ABBREVIATED PLAT AGENDA

STAFF REVIEW AND RECOMMENDATIONS PUBLIC HEARING MARCH 27, 2024

ABBREVIATED PLAT: TALKEETNA FISH

REVIEWED BY: AMY OTTO-BUCHANAN CASE #: 2024-035

TEST HOLE LOCATION EXHIBIT MAP

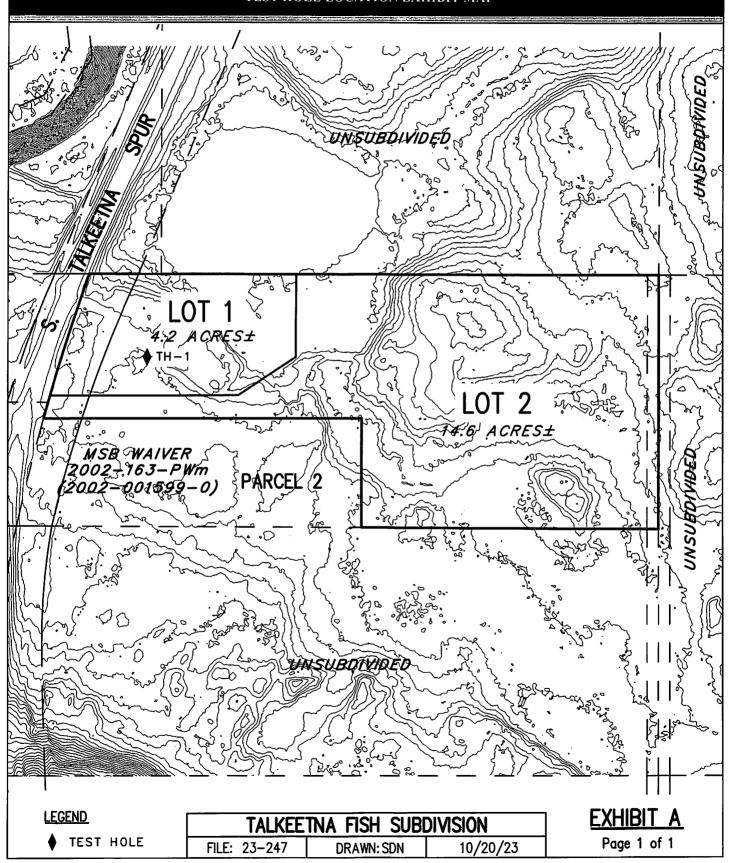
<u>Soils Report</u>: (Exhibit B) A soils report was submitted, pursuant to MSB 43.20.281(A)(1). Bill Klebesadel, PE, notes one testholes was dug to 12'. Receiving soils were SW-GW. Testhole log and a testhole location map are provided. Mr. Klebesadel concludes both lots contains sufficient overall area. Both have at least 10,000 sf of useable building area and 10,000 sf of contiguous useable septic area. Surveyor of record provided a detailed topographic narrative for proposed Lot 2 at Exhibit B-5. Topographical Mapping and As-Built at Exhibit C.
